TOWN OF UNDERHILL

Development Review Board

TIJAN 2019 FAMILY TRUST
Subdivision Amendment Review
Docket #: DRB-20-05

Subdivision Amendment Application of Tijan 2019 Family Trust Pertaining to a Building Envelope Amendment

SECTION 3.18 – STEEP SLOPES

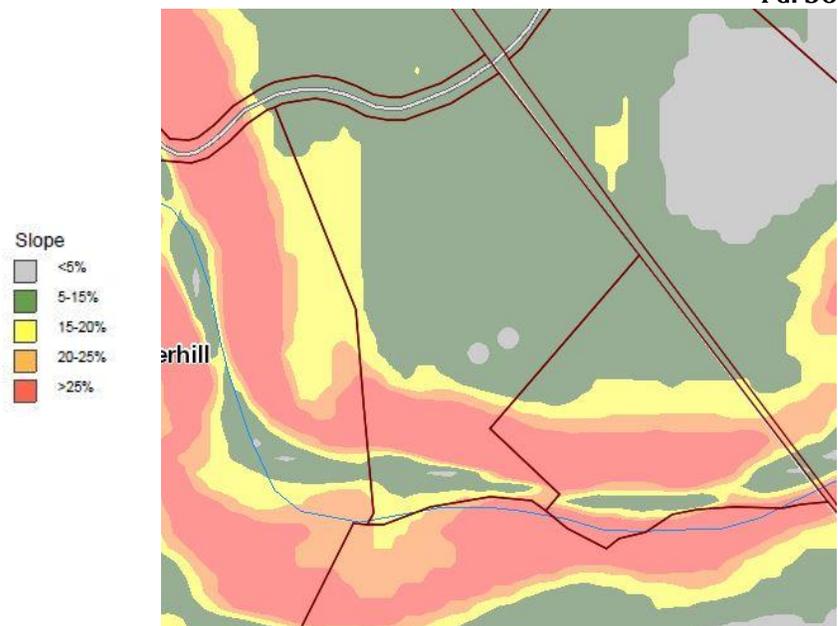
- According to the ANR Atlas website, Areas of steep slope (15%-25%) are located towards the western portion of the property, which will be in the proposed building envelope.
 - The Board should take note if Steep Slopes will be within the proposed envelope, as the ANR Atlas is a planning tool and not necessarily 100% accurate.
- Areas of steep slopes (15-25%) or very steep slopes (>25%) are located in the southern portion of the

property, outside of the proposed building envelope.

- The proposed building envelope appears to conform to the Town’s zoning regulations, as appears to avoid constraints such as wetlands and associated buffers, surface waters and associated buffers, etc.
 - Should the Board determine that the building envelope should avoid areas of steep slope (should they exist as observed during the site visit), the Board could request the Applicant to modify the proposed envelope to exclude those areas.
